TITLE - PROPOSED PLAN LAYOUT				NIHVA TECHNOLOGIES PVT.LTD.PUNE Website - www.nihva.com	
	NAME	SIGNATURE	DATE	CLIENT -	
DRAWN	D.V.		25.07.2023	PRODUCT - RETRACTABLE ROOF	
CHK'D	P.M.		25.07.2023	SITE LOCATION -	
APPV'D	V.T.		25.07.2023		
if any queries contact - supportautomation@nihva.com				REVISION - 01	27-05-2024
ALL DIMENSION ARE IN mm		A3		SCALE - 1.1	SHEET 1 OF 1

DETAIL A
SCALE 1 : 30

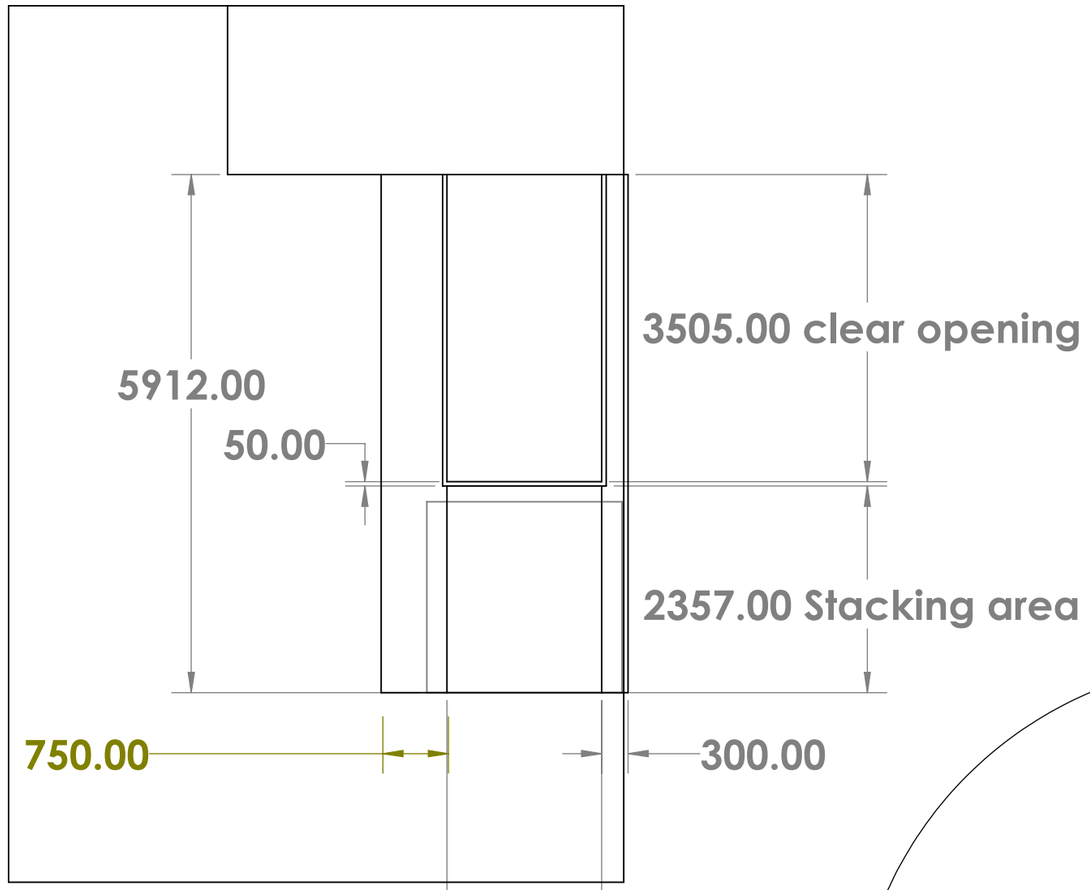
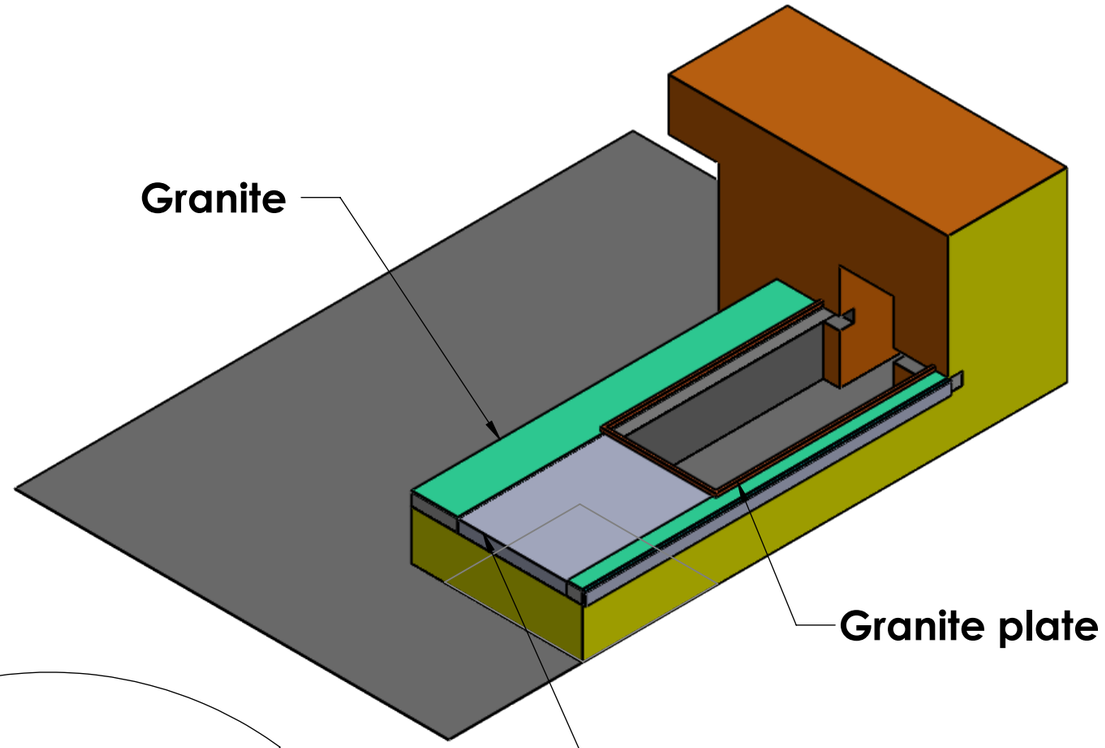
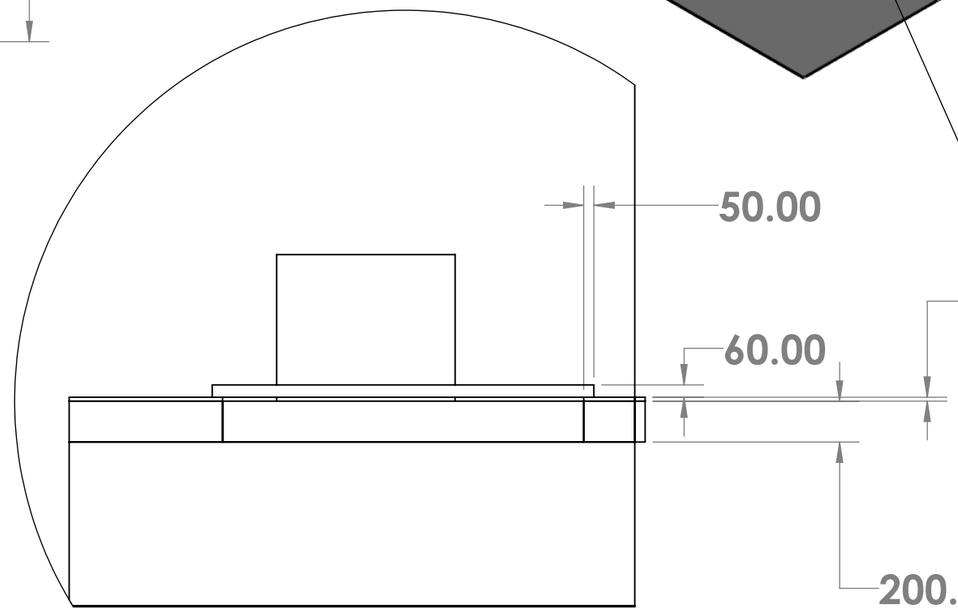
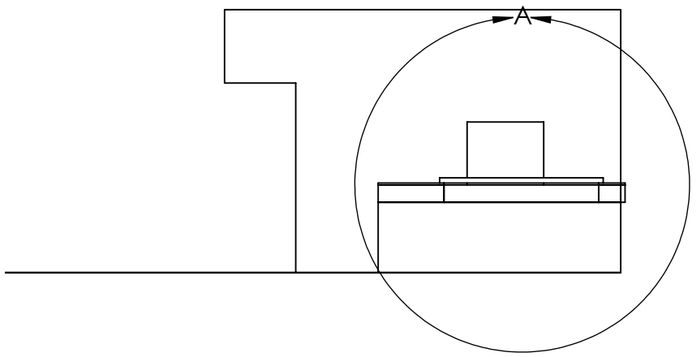
NOTE-
1) R01:- 250 MM TACK MTG SIZE IS CHANGE BY 300 MM BECAUSE OF TRACK AND MARBAL PLATE IS FALL
